Design Review Committee

Case File Number: PLN16-295 November 30, 2016

Location: 1314 Franklin Street

Proposal: Proposal for a mixed use development containing

FLOOR PLAN - LEVEL 01 DESIGN REVIEW PACKAGE

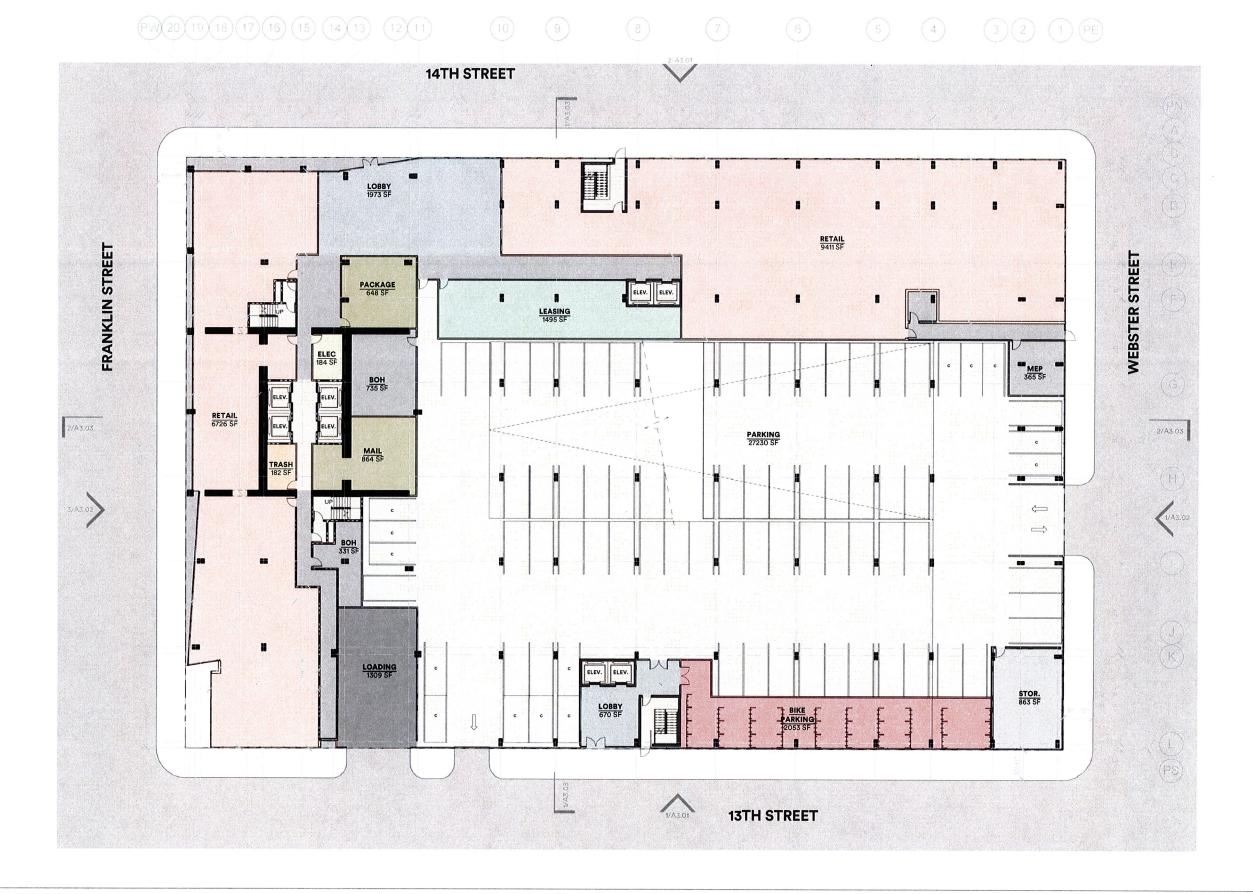
While staff understands that this is an early submittal that was put forth primarily to receive feedback on the overall project concept and tower design, staff has a number of comments on the ground floor treatment of the building which has not been completely refined as of yet. The applicant should look to create a clearly defined storefront spacing pattern of commercial bays and look to incorporate elements such as storefront bulkheads, pilasters, transoms and awning elements. They should also look to create a clearly prominent and separate lobby entrance into the residential portion of the building to differentiate it from the commercial storefronts. This could also act as a break between the storefronts of the eight story base building and the tower, where it may be appropriate to create a different storefront rhythm so it is not so repetitive for the entire city block.

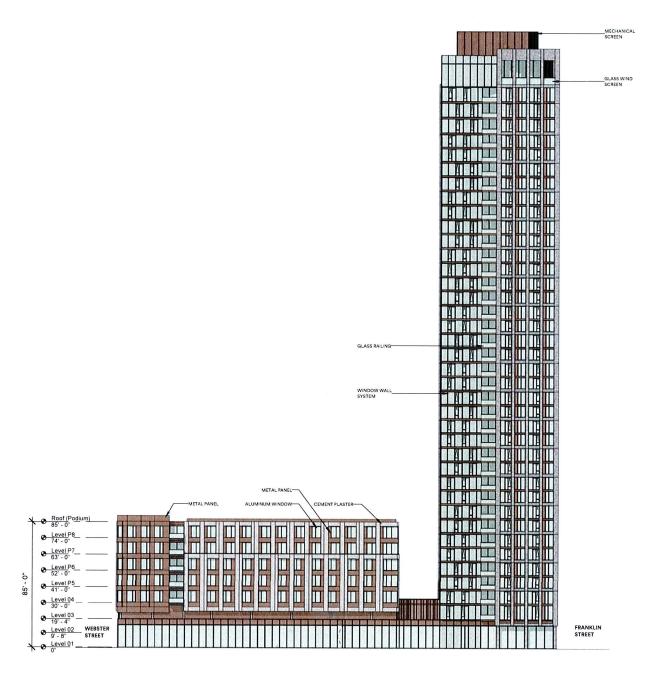
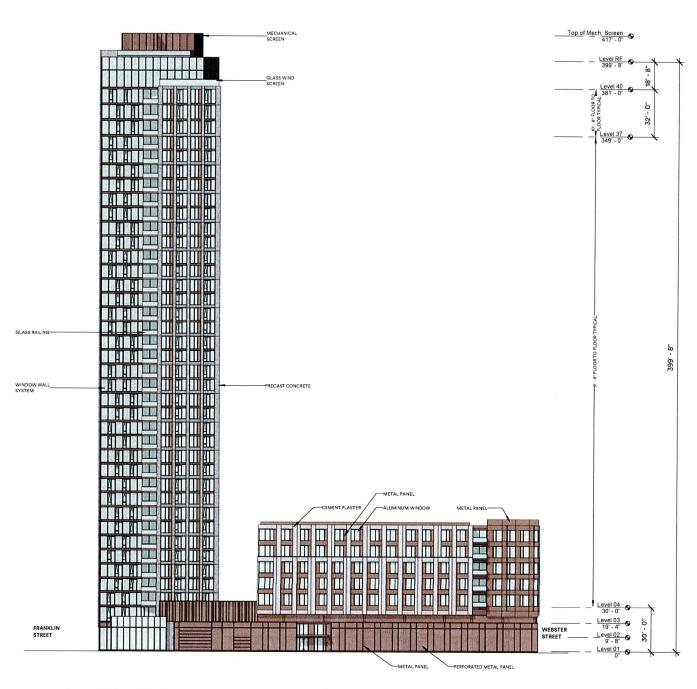
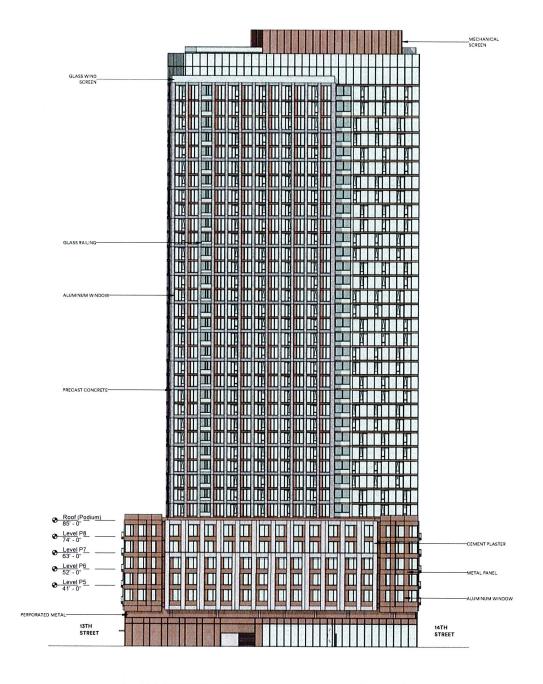
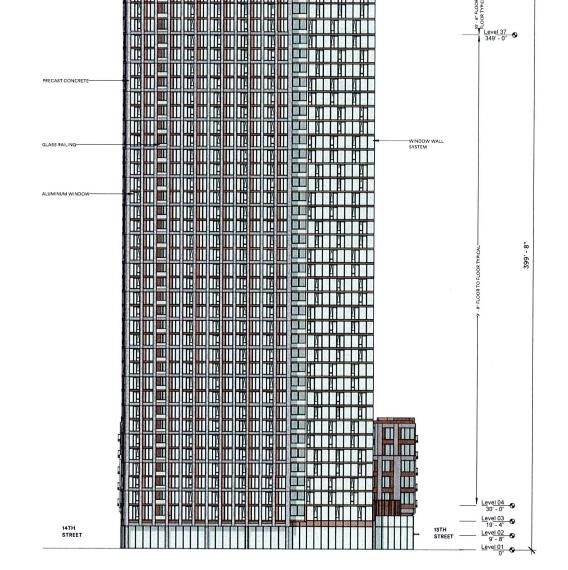
The parking as proposed includes two basement levels, a ground and second level behind the double height active commercial space along 14th and Franklin Streets, and an additional third upper level. As currently designed the third upper level is exposed on three facades of the building and is proposed to be screened by perforated metal panels. Staff recommends, consistent with the Lake Merritt Station Area Design Guidelines, that the upper parking levels should have facades consistent with the other upper levels of the building (floors 4-6) and the building façade material and opening patterns should be cohesive as one unit to establish the "middle" of the building.

On the "back side" of the project along the Webster and 13th Street frontages more measures should be taken for the ground level parking as seen from the pedestrian experience. As currently proposed the façade contains a repeating pattern of metal panels and perforated metal screens to block view of automobiles and allow air circulation into the garage space. Staff recommends that these patterns should be similar to the commercial store front rhythm and the perforated metal areas should be a location in which the applicant looks to incorporate the required public art component of the project. These areas can also be combined with a low raised planter wall as well. For the portion of the building where the bike storage is proposed, staff recommends the applicant also look into providing storefront type glazing even if some sections are opaque and back lit.
